3. BOA-23-10300316: A request by Brandon Melland for 1) a 5' and 2' special exception from the maximum 3' and 6' fence height to allow an 8' privacy fence in the front, side, and rear yards, and 2) a request for a variance from the fence materials to allow for a corrugated metal fence on the property, located at 10601 and 10515 Nacogdoches Road. Staff recommends Approval for the Fence Height Special Exception. Staff recommends Denial for Fence Material Variance. (Council District 10) (Melanie Clark, Planner, 210-207-5550, melanie.clark@sanantonio.gov, Development Services Department)

Agenda Memorandum

CASE NUMBER: BOA-23-10300316

LOCATION: 10601 and 10515 Nacogdoches Road

Site Plan/Materials

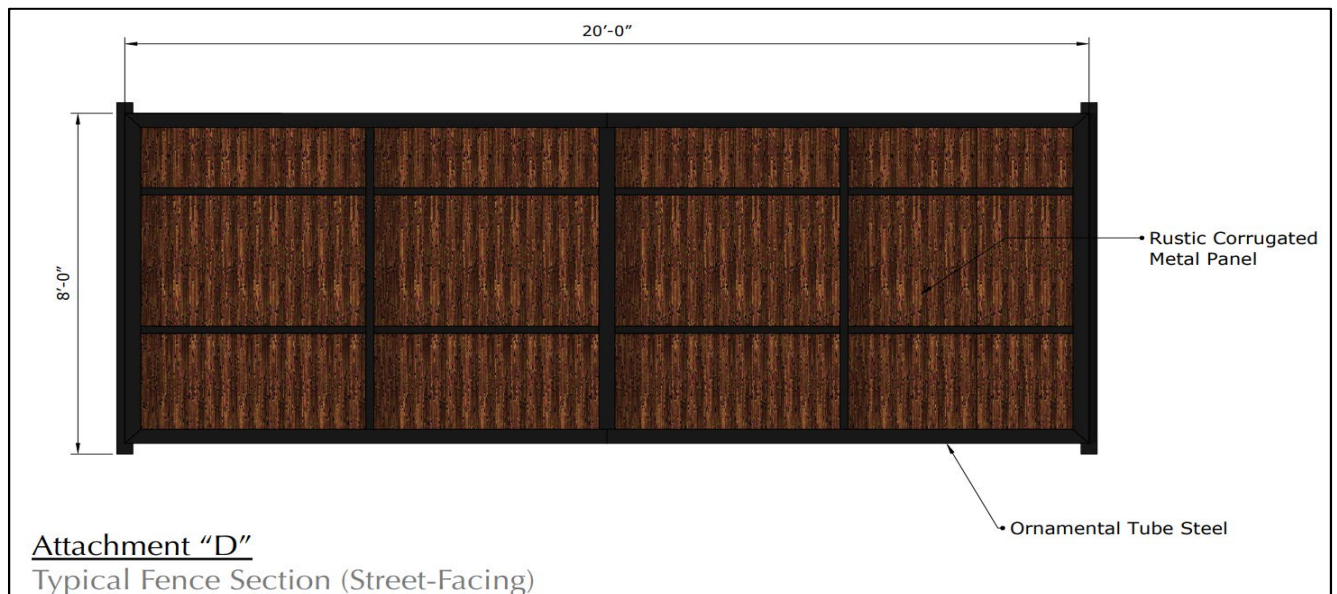
1). A variance from the fence materials to allow for a corrugated metal fence in the front yard

2). A 5' special exception from the maximum 3' fence height to allow an 8' privacy fence in the front yard.

Proposed 8-Foot Tall
Ornamental Steel and Rustic
Corrugated Metal Fence
(digitally superimposed)

Staff recommends Denial in BOA-23-10300316 based on the following findings of fact:

1. The public and immediate property owners can observe the materials from the public right of way.
2. The use of corrugated metal fencing was not observed in the surrounding area.
